Ensuring horizontal margin in Annex 120G

(comment #41)

Adam Healey and Raj Hegde

Broadcom Inc.

Alternative to eye symmetry mask width (ESMW)

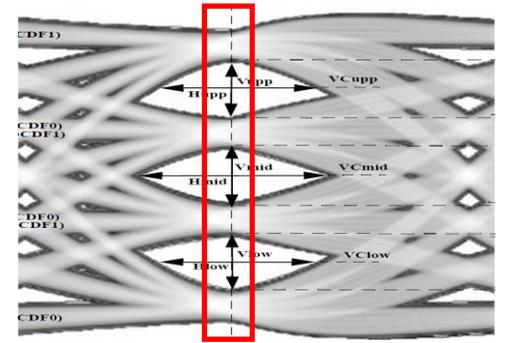
- Draft 1.3 refers to 120E.4.2 for eye height measurement method
- 120E.4.2 states that the cumulative distribution function (CDF) of the signal voltage is constructed from samples “within 0.025 UI of time TCMID”
- Eye height (EH) and vertical eye closure (VEC) are derived from this signal voltage CDF

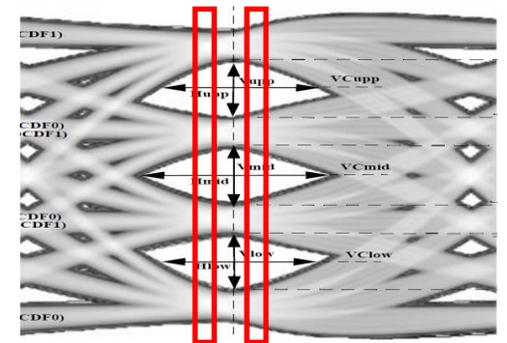
- Histogram window could be expanded
- Window width is effectively a uniform jitter distribution or “timing uncertainty” allowance for actual receivers
- Reduced EH and VEC with higher jitter and eye asymmetry

- Could also consider different allowances for static and random timing errors
- Note: Vertical metrics that consider timing uncertainty facilitate optimization of the transmitter equalizer and reference receiver

Expand histogram window
(D1.3 comment #41)

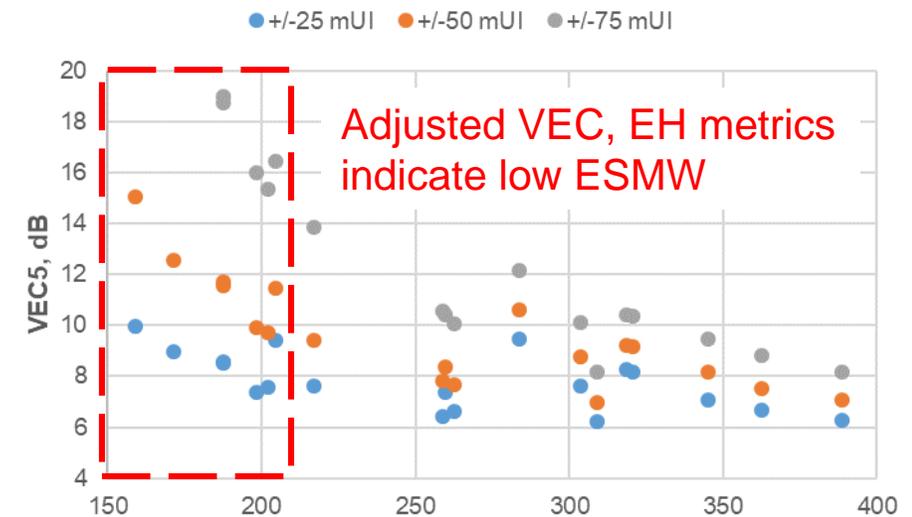
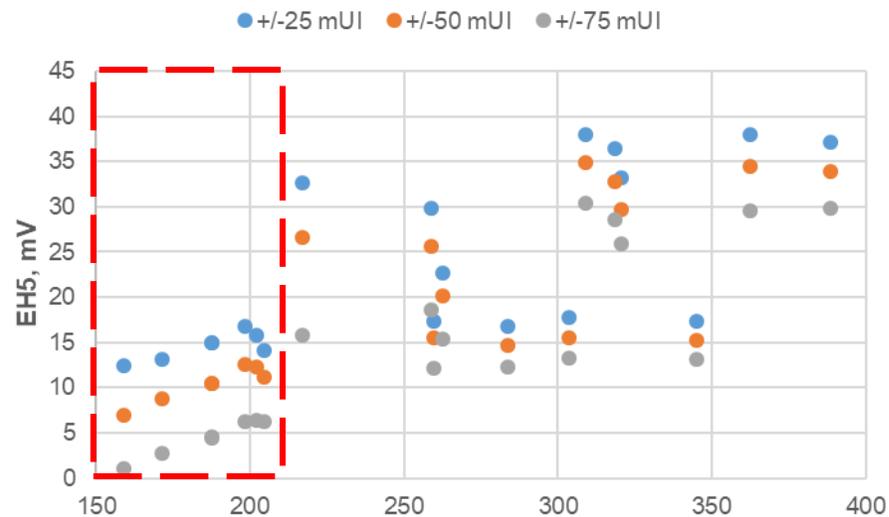
Measure at time offsets

- 2 measurements centered at time offsets indicated in the legend
- 40 mUI histogram window
- Choose the worst result

EH sensitivity to jitter

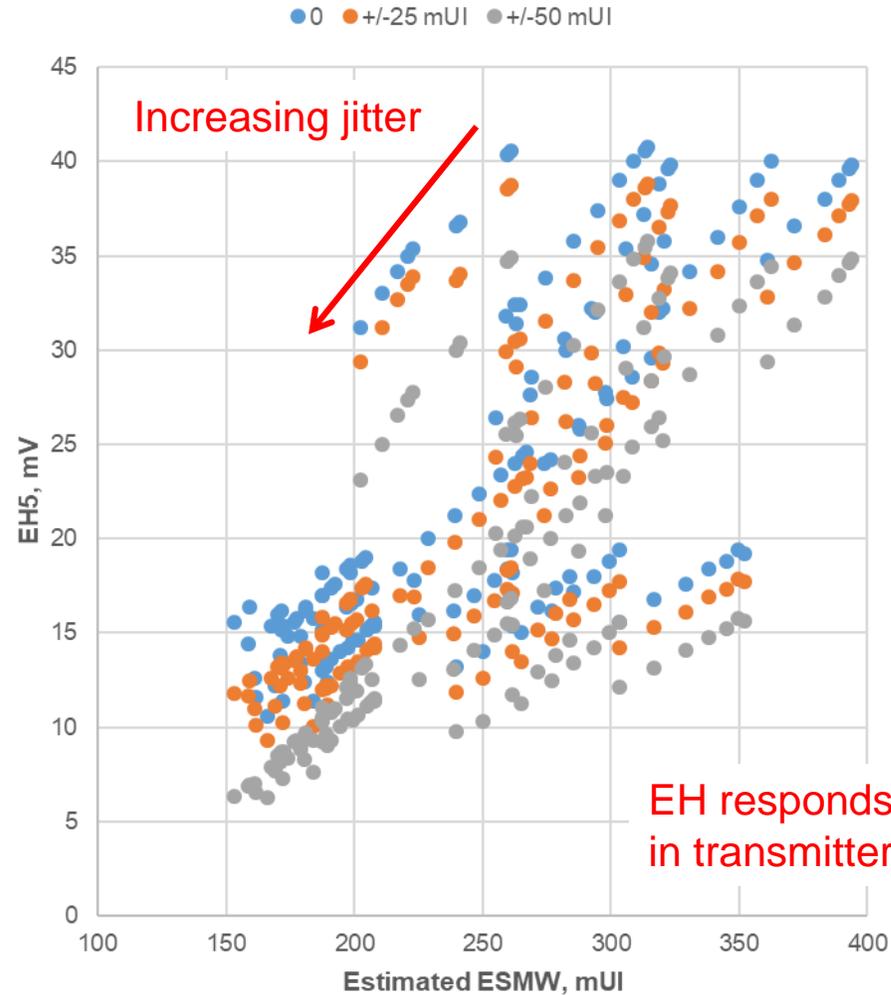
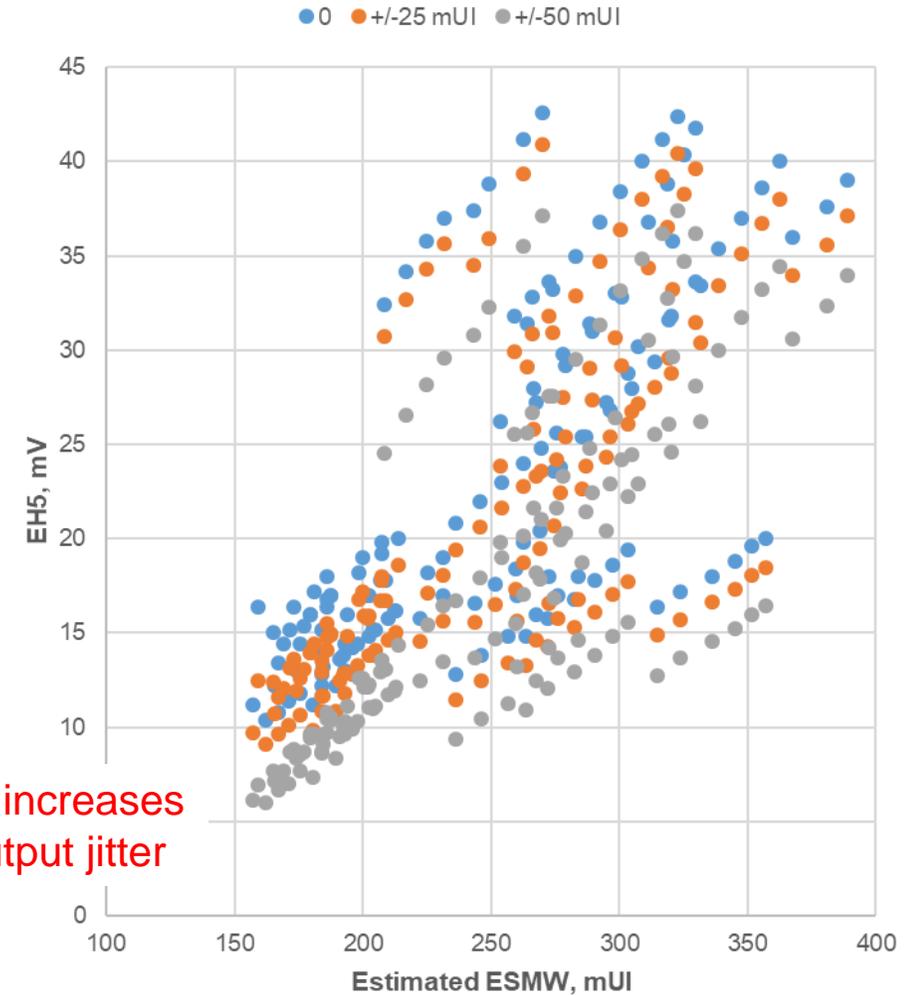
- 2 measurements centered at time offsets indicated in the legend
- 40 mUI histogram window except for offset 0
- Choose the worst result

VEC sensitivity to jitter

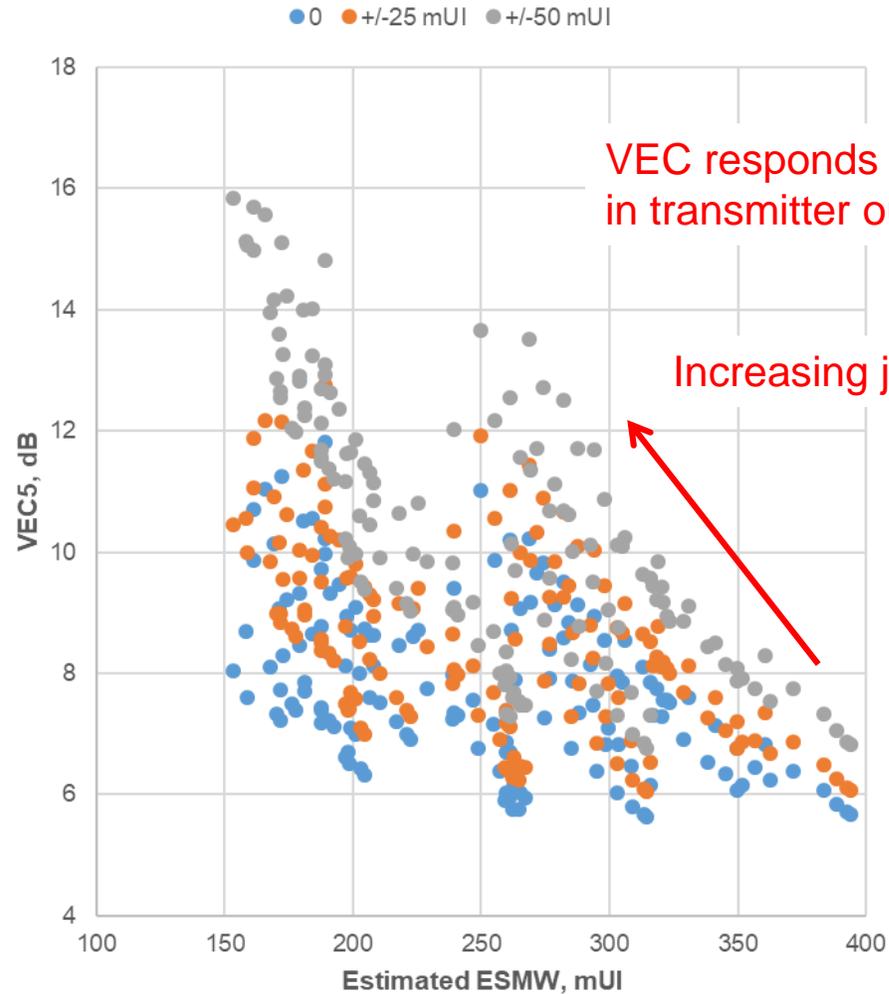
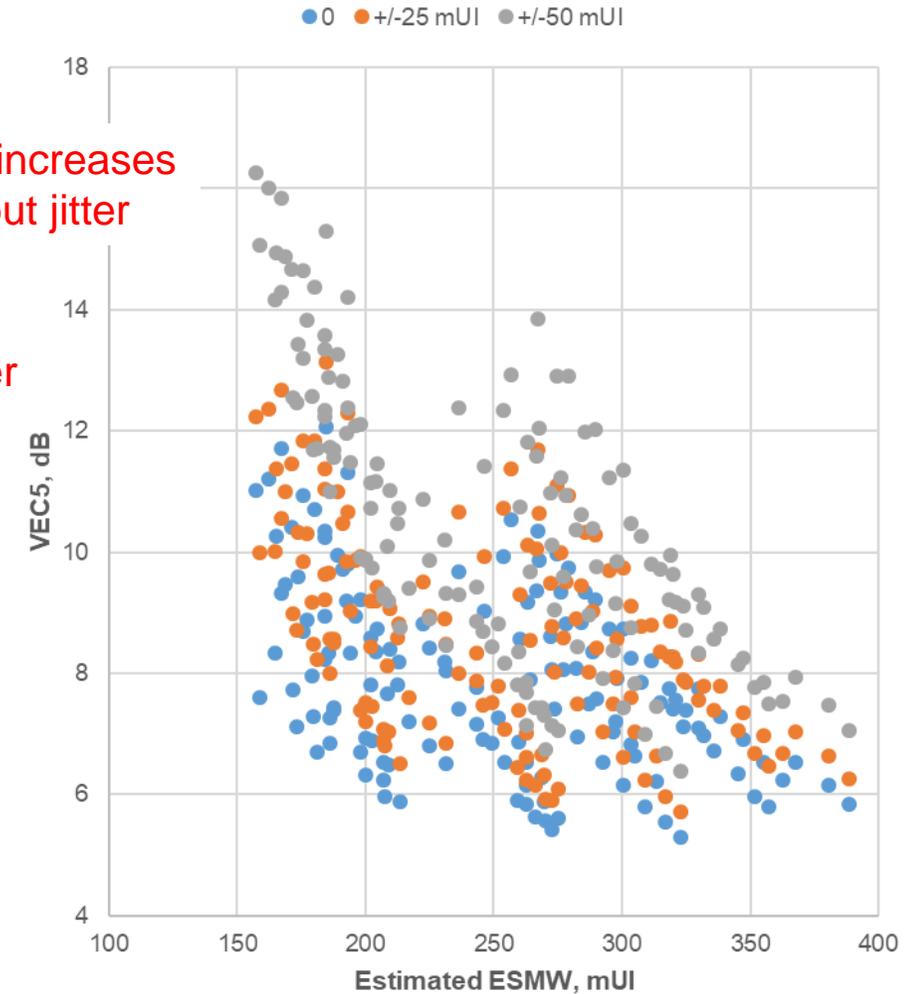
- 2 measurements centered at time offsets indicated in the legend
- 40 mUI histogram window except for offset 0
- Choose the worst result
